Sundry Print Report

Well Name: MESA VERDE WC UNIT Well Location: T24S / R32E / SEC 16 / County or Parish/State: LEA /

Notice of Intent

Type of Action: APD Change

WELL LOCATION AND ACREAGE DEDICATION PLAT

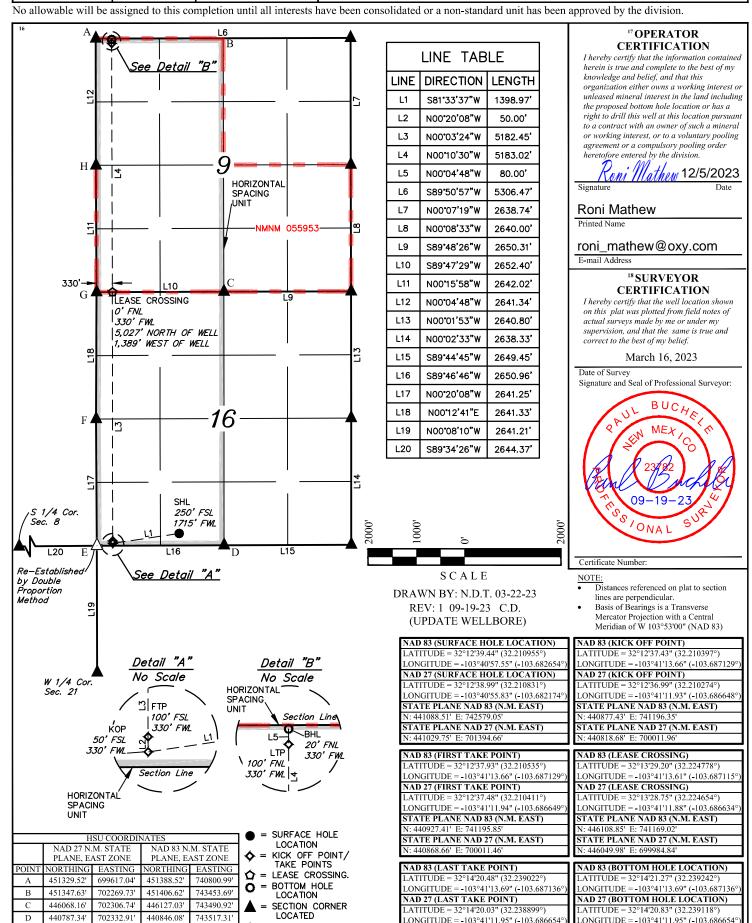
OXY APD CHANGE SUNDRY LIST

ITEM	PREVIOUS	UPDATE
NAME	NA	
NSL	NA	
SHL	NA	
PAD	NA	
BHL	20' FNL X 440' FWL	20' FNL X 330' FWL
HSU SIZE, ACRES	NA	
POOL	NA	
TARGET FORMATION	NA	
TVD	13107'	12851'
SURFACE CASING	14.75" HOLE, 10.75" CASING, 40.5 LBS, J-55, BTC	14.75" HOLE, 10.75" CASING, 45.5 LBS, J-55, BTC
INTERMEDIATE CASING	9.875" HOLE, 7.625" CASING, 26.4 LBS, L-80 HC, BTC	9.875" HOLE, 7.625" CASING, 29.7 LBS, L-80 HC, BTC
PRODUCTION CASING	6.75" HOLE SIZE, 5.5" CASING, 20 LBS, P-110, DQX	6.75" HOLE SIZE, 5.5" CASING, 23 LBS, P-110, SPRINT-SF
LINER OR TIE BACK	N/A	
CEMENT - SURFACE (TAIL)	955 SX, 14.8 LBS, 1.33 YLD, Class C + ACCEL, EXCESS 100%	807 SX, 14.8 LBS, 1.33 YLD, CLASS C + ACCEL, EXCESS 100%
CEMENT - INTERM 1ST (TAIL)	760 SX, 13.2 LBS, 1.65 YLD, Class H + RETARDER, DISP, SALT, EXCESS 5%	725 SX, 13.2 LBS, 1.68 YLD, CLASS C + RETARDER, DISP, EXCESS 5%
CEMENT - INTERM 2ND (TAIL)	884 SX, 12.9 LBS, 1.92 YLD, Class C + ACCEL, EXCESS 10%	1126 SX (BH), 13.3 LBS, 1.71 YLD, CLASS C + ACCEL, EXCESS 25%

THE TVD, BHL, SURFACE CASING, INTERMEDIATE CASING, AND PRODUCTION CASING ARE CHANGING.
